**Re: Sechelt Aquatic Centre – Use of Genie Z-30/20N Boom Lift on Pool Deck**

Figure 2: Plan View of Backwash and Surge Tank Suspended Slab Area

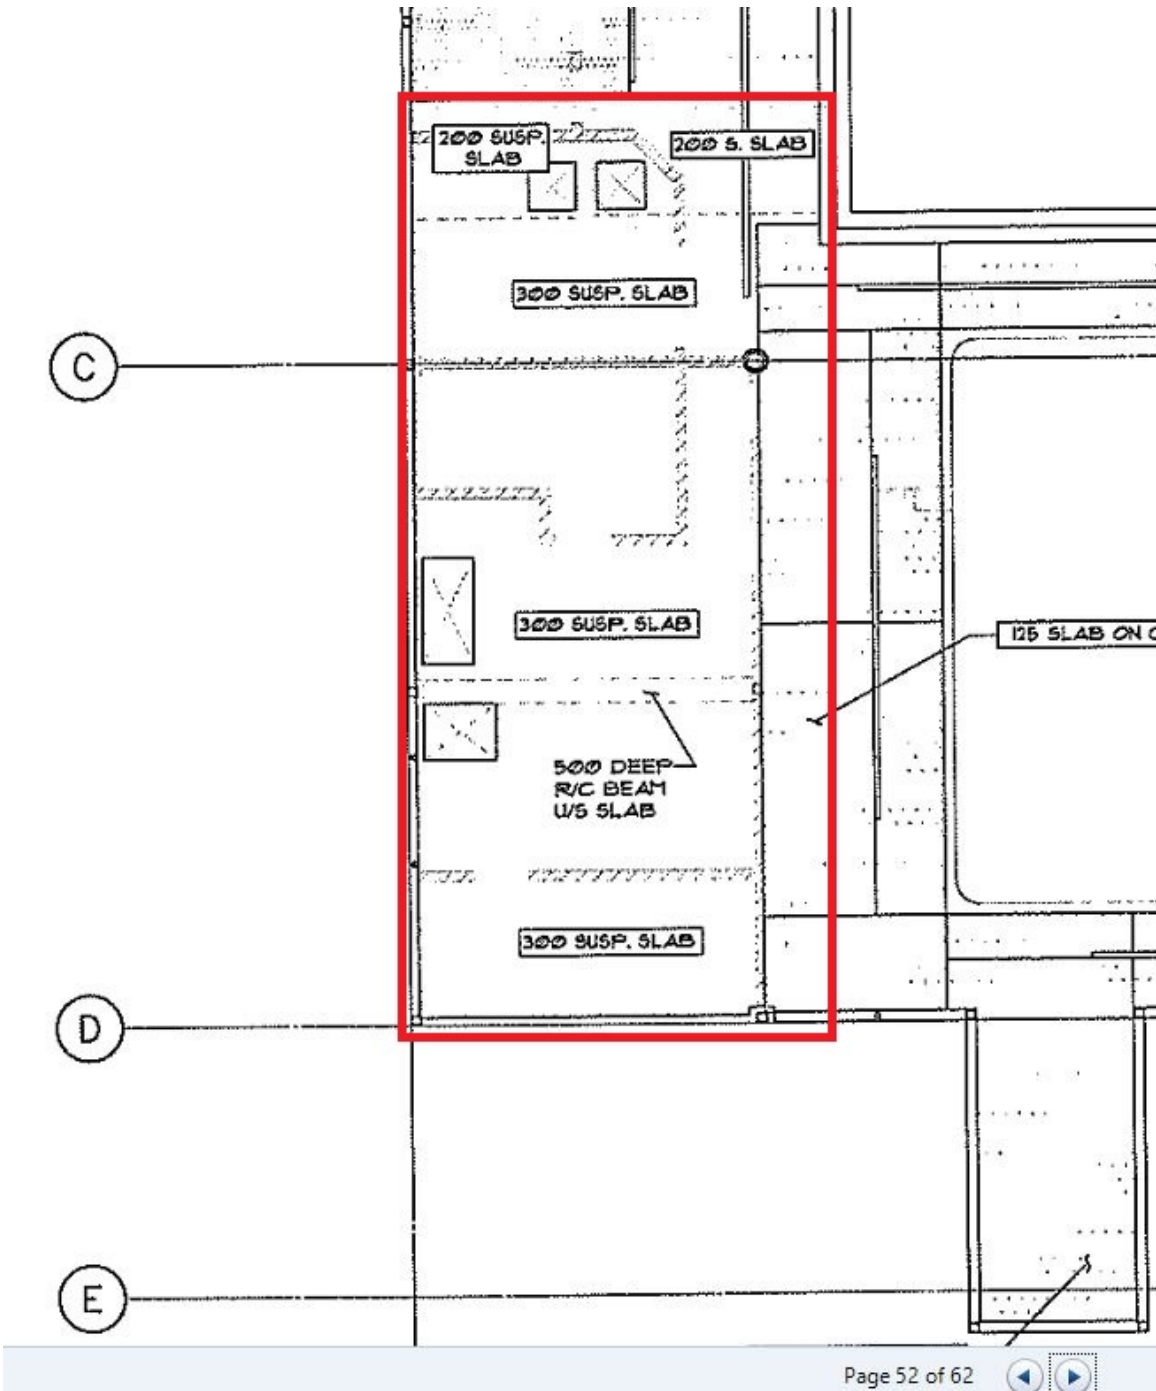
Allester Engineering (A.E.) has reviewed the provided structural and architectural drawings as well as the information regarding the Genie Boom Lift noted above. The lift may only be used on specific slab on grade areas of the pool deck. Due to the weight of the lift 2 layers of 3/4" plywood will be required to be used to protect the pool deck at all times. Please also note that there are areas of the pool deck that are suspended slab over the backwash tank and surge tank. These areas are unable to support the lift and should not be loaded at any time. Please review figures 1, 2, and 3 as well as the architectural and structural drawings for specific locations and communicate to the lift operator which areas of the slab should not be loaded. It would be advisable to mark these no-go areas with cones while the lift is in operation.
